## Technical Review of Tree Related Issues in ACE Paper 8/2023

(Rev.2)

This Paper summarizes the findings of a Technical Review of Sections 5, 6 and 8 of ACE Paper 8/2023: Reporting of the Additional Information prepared for the EIA Report on “Technical Study on Partial Development of Fanling Golf Course – Feasibility Study”. Reference is also made where appropriate to the original Environmental Impact Assessment (EIA) Report that was uploaded for public viewing in June 2022.

Figure 5.1 – Typical Example of the Huge Inaccuracies in the EIA Tree Survey

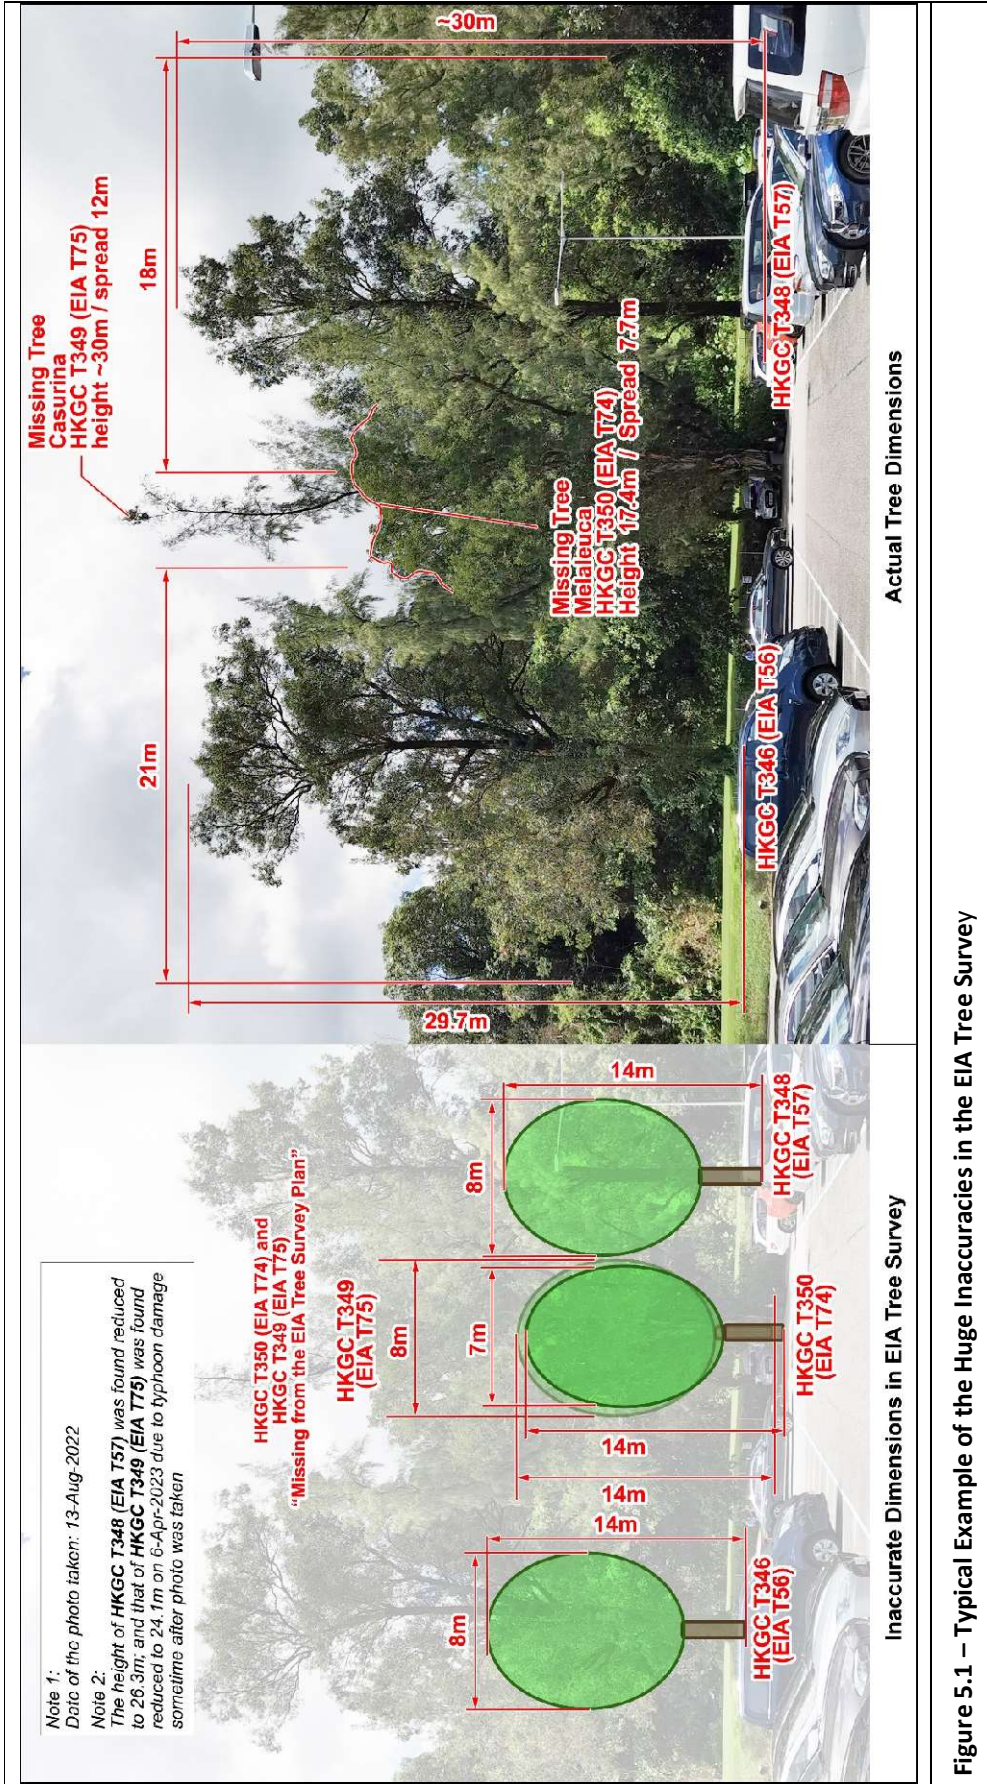
The entire Section 5 is seriously flawed and invalid because it is based in a grossly inaccurate and incompetent Tree Survey which has failed to record 460 trees located on site and which records grossly inaccurate (far too small) tree dimensions (DBH, height, canopy spread), wrongly mapped trees locations and incorrect species identification. **Figure 5.1** illustrates typical examples of the huge inaccuracies in the EIA Tree Survey.

Figure 5.2 - Tree Protection Zones for the 29 Large Trees of Particular Interest in Sub-Area 1 in accordance with GLTMS Guidelines

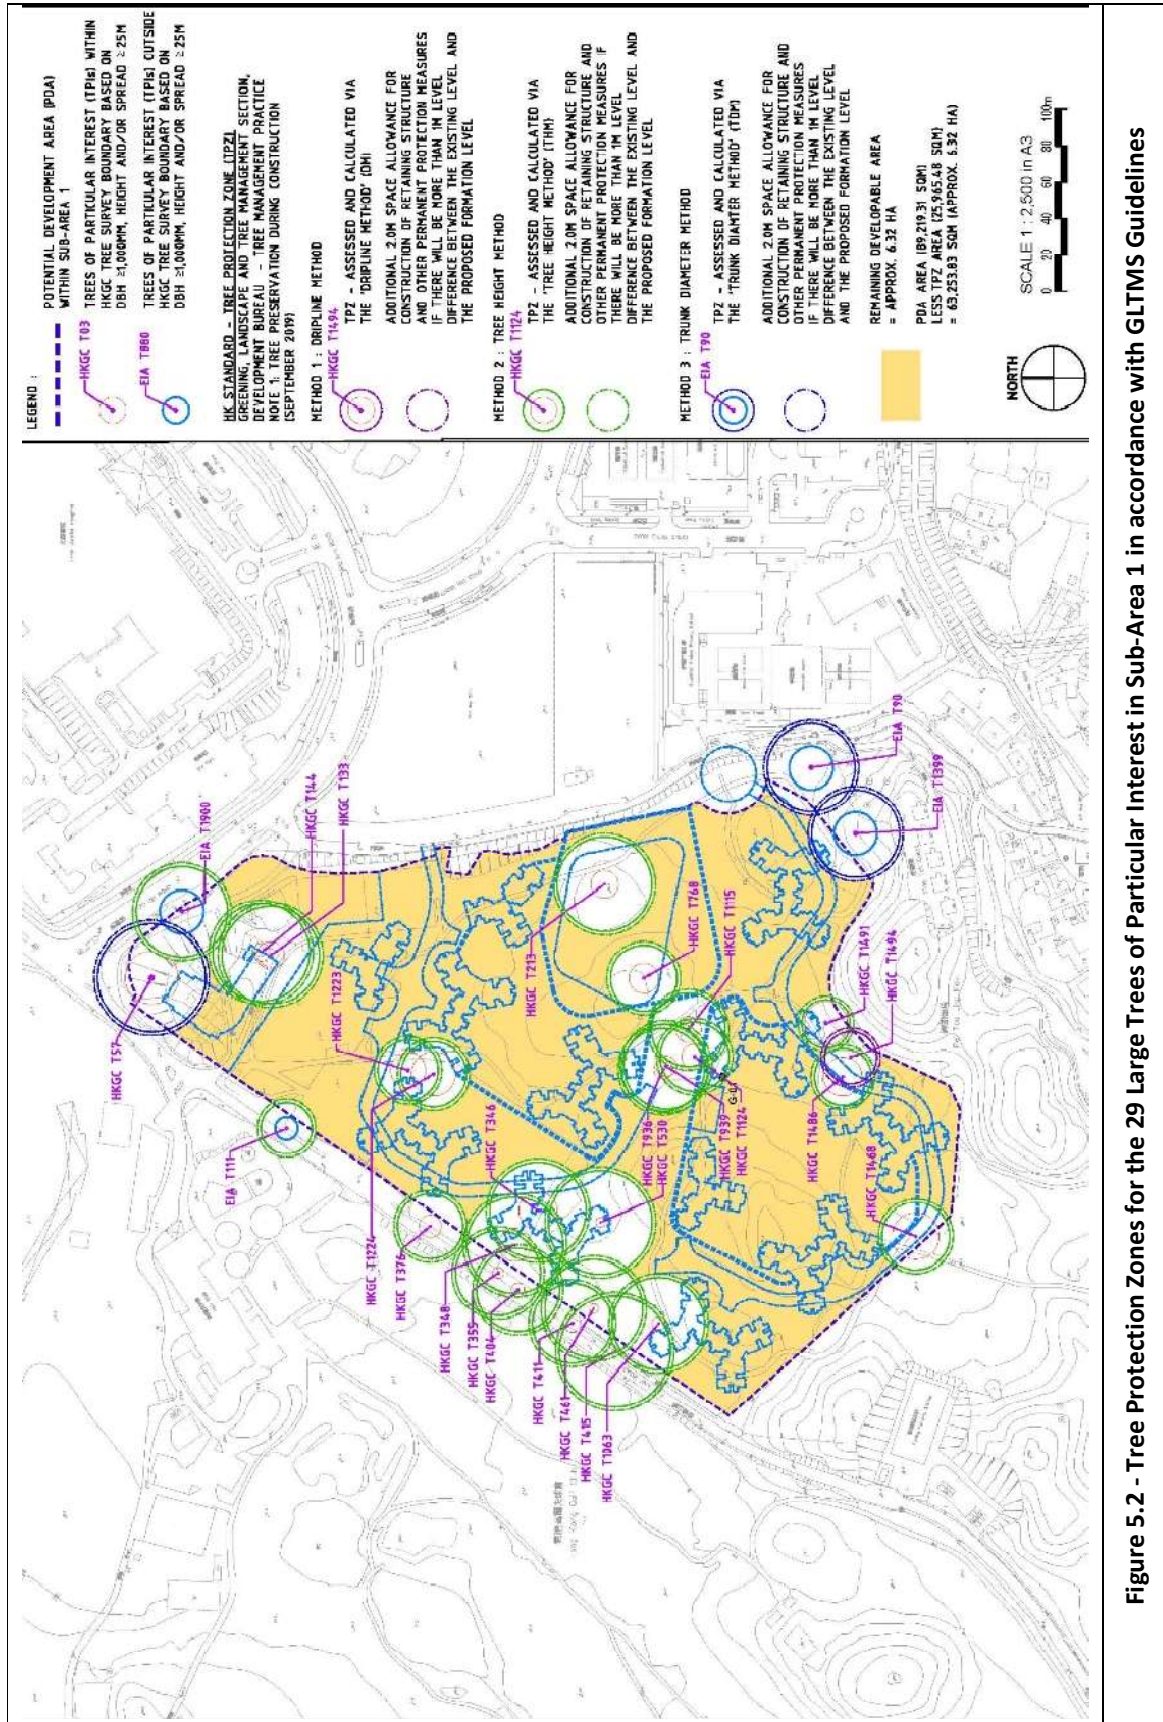
3 different methods to be used depending on the nature, shape, age of the tree being protected. The Dripline Method proposed in “Figure 5C – Additional set back from the tree protection zone” is the most basic ‘Method 1’. Better methods, especially for the protection of large TPIs and OVTs, are Method 2: Tree Height Method and Method 3: Trunk Diameter Method. **Figure 5.2** shows TPZs for the large TPIs in Sub Area 1 prepared in accordance with best practices described in the DEVB GLTMS guidelines. It can be clearly seen on **Figure 5.2** that the TPZs are incompatible with the proposed building layout.

**Numbers of OVTs in Existing PHDs.** The claim in paragraph 5.4.3 that there are “*abundant cases of OVTs being maintained within the existing housing developments of HD*” is false and misleading. In all of Hong Kong’s many HD’s there are **only 3 OVTs**, which are the 3 OVTs illustrated in Figures 5F, 5G and 5H. Three OVTs in all of HK’s HDs cannot be described as “abundant” – a more accurate adjective would be “**rare**”. It is fallacious to claim that the dense development proposed at Fanling would be capable, as claimed in the EIA, of retaining 11 large TPIs adopting Government’s own standards for tree protection, as **Figure 5.2** shows clearly.

For the reasons explained above, the PHD layout in *Figure 6A – Location of Woodland suggested by ACE to be preserved* fails to show the correct number and locations of existing TPI locations and their necessary TPZs derived in accordance with Government’s own tree protection guidelines. See **Figure 5.2** for the correct situation.

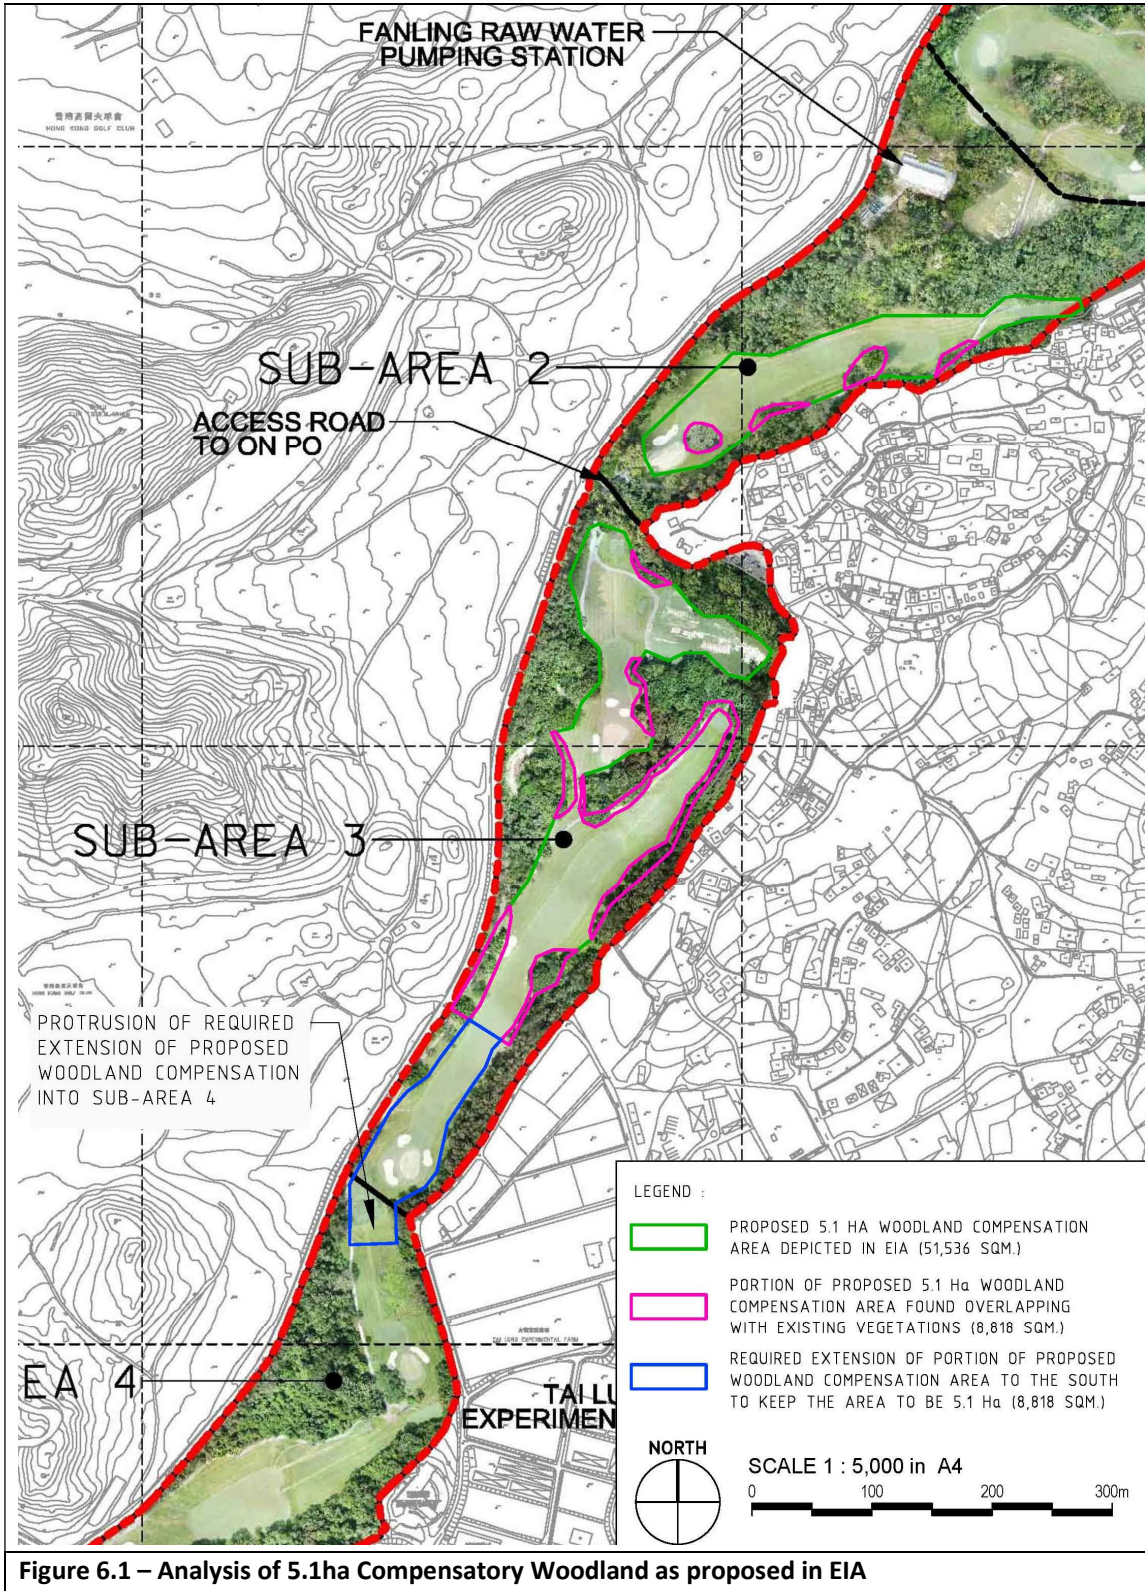
It is noted that contrary to previous promises made by CEDD in 2022 to ACE and to the Town Planning Board, the layout of the PHD is **NOT** revised to mitigate tree and landscape impacts.

As mentioned above, the proposed 5.1ha woodland compensation is inconsistent with the tree compensation proposal described in ACE Paper 8/2023 section 5 and illustrated in Figure 5B. Furthermore, the 5.1ha is inaccurately plotted in the original EIA - some of the compensation woodland planting is shown in locations where there is existing woodland to be retained. This means that to create 5.1ha of woodland it would be necessary to extend the planting further south into Sub-Area 4, thus greatly endangering the survival of the Chinese Swamp Cypress located there. See **Figure 6.1** which shows the actual area required to provide 5.1ha of woodland planting.

Figure 8.1 – Composite Diagram of Sun Path Analysis at Hourly Intervals from Sunrise to Sunset at Winter Solstice

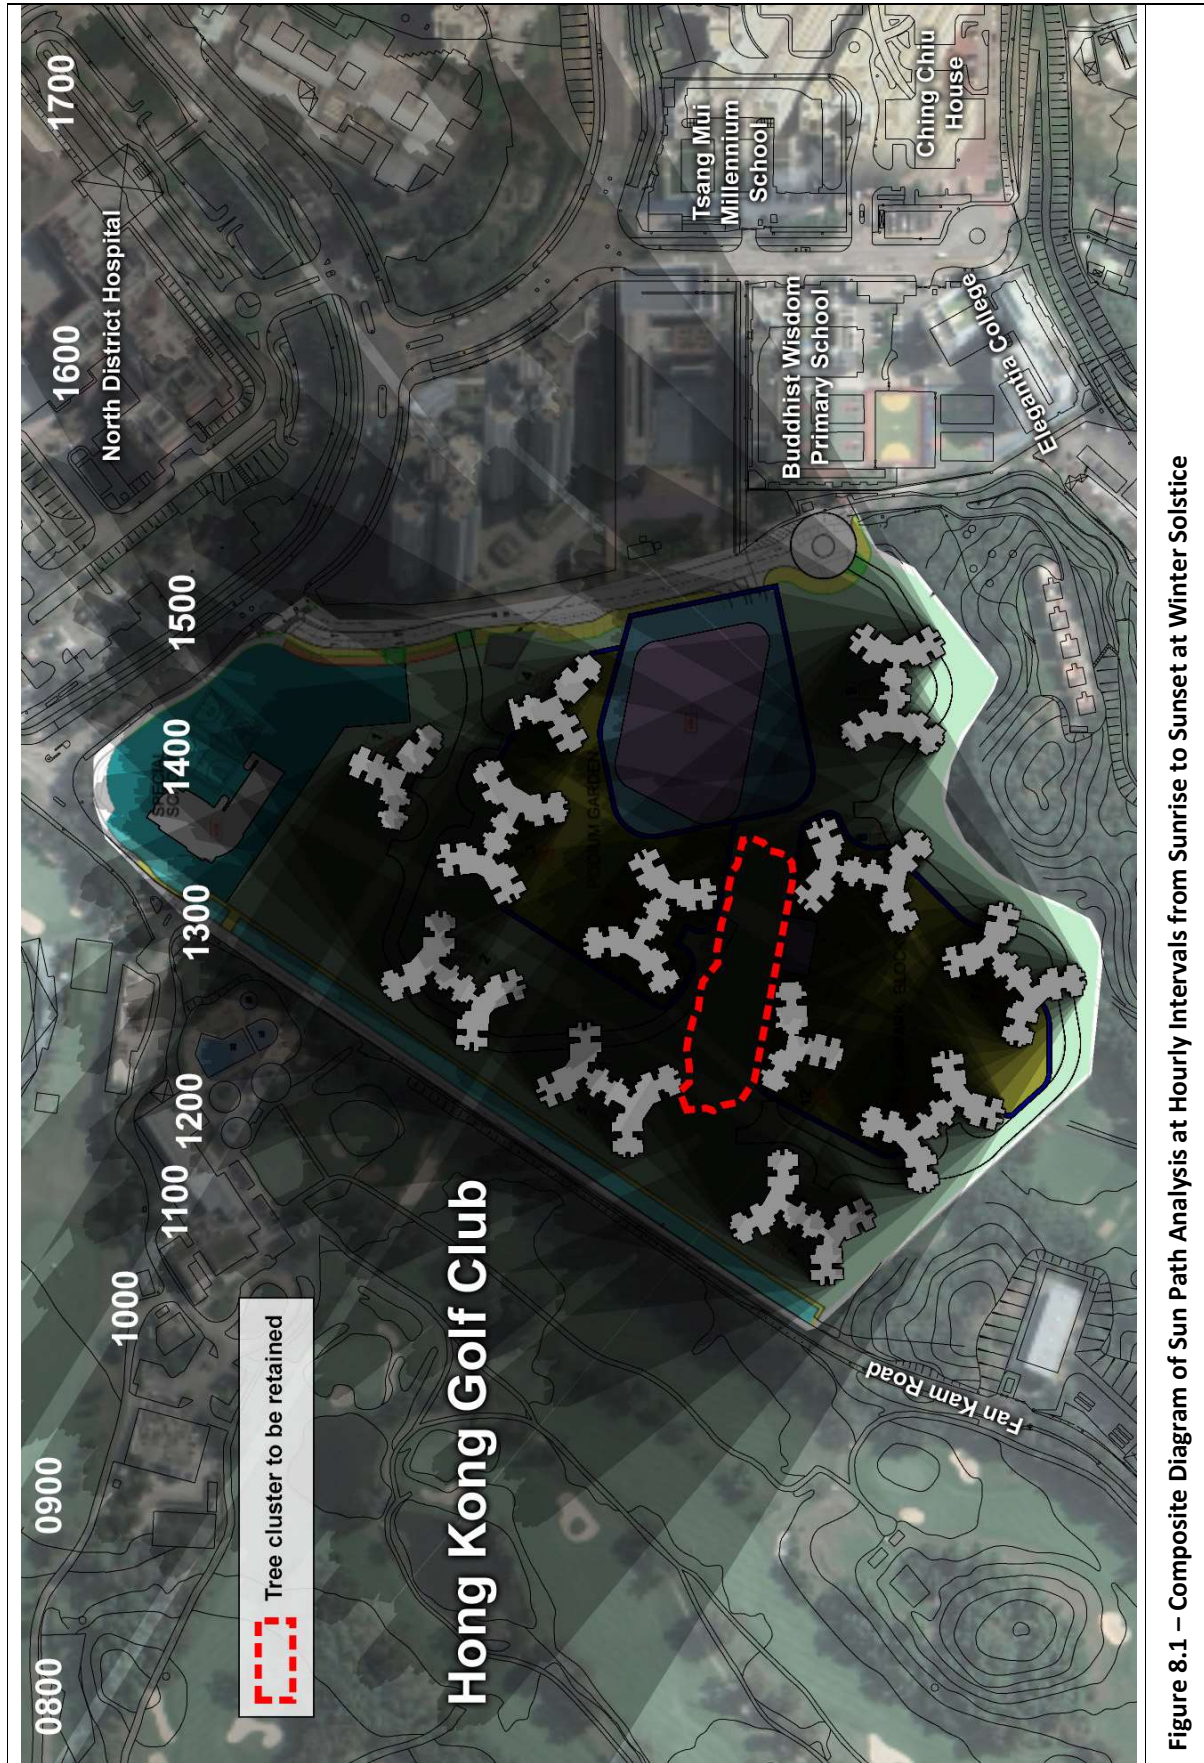
- b. **Tree Count in paragraph 8.2.2 is wrong.** Due to the poor quality of the EIA Tree Survey, the tree count in the tree cluster is incorrect.
- c. **Sun Path Analysis.** Paragraph 8.2.5 states “*In spring equinox (春分), summer equinox (夏至), autumn equinox (秋分), the retained tree clusters would be able to receive direct sunlight, although in some time of a day, the trees may be shaded by the proposed housing development. The shading is not significant.*” This statement greatly understates the actual shading that will be caused by the buildings, and it is wrong to say the shading is not significant. (Furthermore, there is also no such astronomical event as ‘summer equinox’ – the correct astronomical event is the “summer solstice” - this appears to reveal the consultant’s basic misunderstanding of the information they are trying to present.) Hourly sun-path diagrams for the Winter Solstice and the Spring and Autumn Equinoxes are provided in **Annex 1**. Composite sun-path diagrams are provided in **Figures 8.1 to 8.3**. Sun-path mpegs are also made available. It may be seen from composite diagrams in **Figures 8.1 to 8.3**, the hourly diagrams in **Annex 1** and the mpegs that the tree cluster is surrounded to the north and south by the very tall housing blocks and will receive less than 1 hour per day of sunlight at the Winter Solstice and less than 4 hours per day at the Spring and Autumn Equinoxes. This means the tree cluster will receive less than 4 hours per day of direct sunlight for more than 6 months of the year, which constitutes a very significant and serious shading effect, contrary to the claims in ACE Paper 8/2023. Other TPis which are (unrealistically) being proposed to be retained within the scheme would suffer even more shading than the tree cluster. This is a most significant change from the current situation in which all trees have direct sunlight from soon after sunrise to just before sunset. To say that the shading is not significant is quite incorrect and very misleading.

- d. **Dr Kuo’s advice is based on wrong information.** We would agree with Dr Kuo’s advice that “*mature trees being periodically shaded for two months in winter, while receiving direct sunlight in other time of the year, would not be significantly impacted in health.*” **But, as explained above and as illustrated in Figures 8.1 to 8.3, the sun-path diagrams in Annex 1 and the mpegs, the degree of shading described in the above quote is not the actual situation that will result from the proposed PHD.** Dr Kuo therefore appears to have been misled.
